SERVICE BULLETIN

No. 540A

Piper Aircraft Corporation

Inspection and Reinforcement of Stabilator Tip Tube and Weight Assembly.

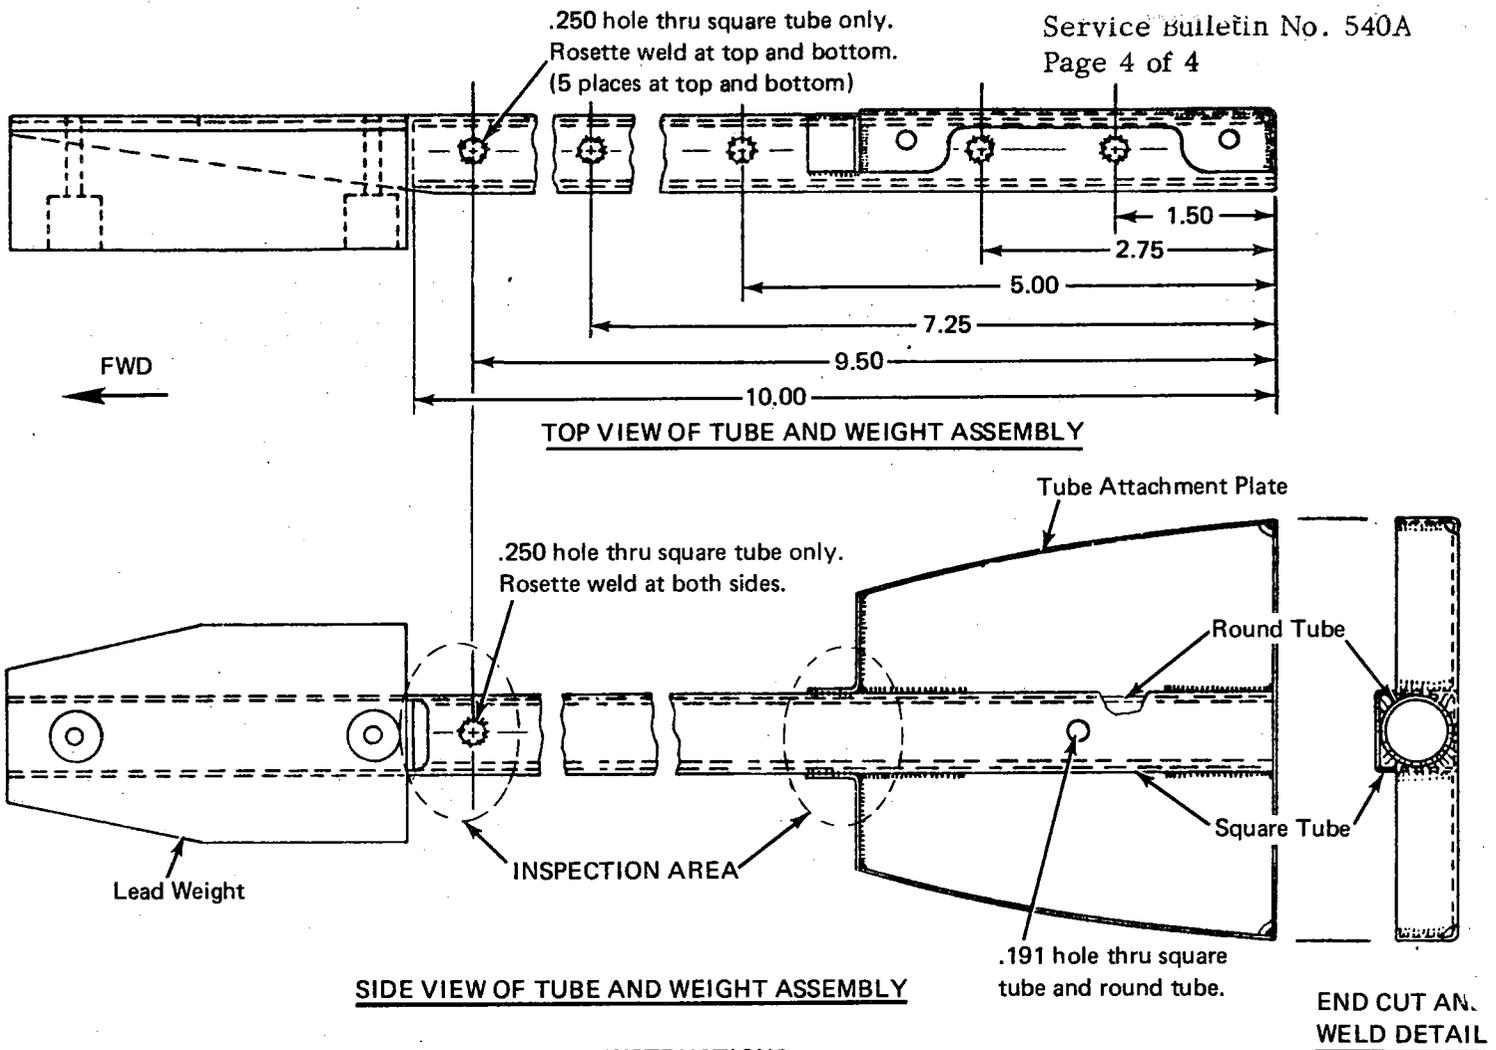
Field reports indicate cracks have been found in the Stabilator Tip Tube and Weight Assembly, Piper Part Number 15658-20. The cracks may be located at either or both ends of the squared tube portion of the assembly (i.e., where the tube joins the weight, and/or where the tube joins the outboard rib attachment plate). If cracks are present - and corrective action not taken - this condition could result in separation of the weight from the tube.

1. Remove tip assembly from left and right stabilators.
2. Using a magnifying glass, inspect the square tube on the tube and weight assemblies to determine if any cracks are evident. See inspection area on above sketch.

- b. Cut or drill hole in the end of the tube attachment plate to allow a 5/8 inch diameter tube to be inserted into the square tube.
 - c. Locate and drill twelve (12) .250 holes in the square tube as shown.

- d. Insert a 10 inch length of round steel tube (5/8" x .058 Type 4130 Cond. N) into the square tube and rosette weld the tubes together at the twelve (12) .250 holes.

- e. Weld shut the area around the hole in the attachment plate and the tubes.
 - f. Weld all cracks shut that were discovered when inspecting the square tube. CAUTION: If welding cracks near the lead weight, use TIG or MIG weld instead of Oxy-Acetylene.

- g. Drill a .191 hole through the round tube using existing hole in square tube as a guide.
 - h. Clean, prime and paint tube and weight assembly.
 - i. Reinstall the tube and weight assembly to the stabilator using existing attachment hardware.
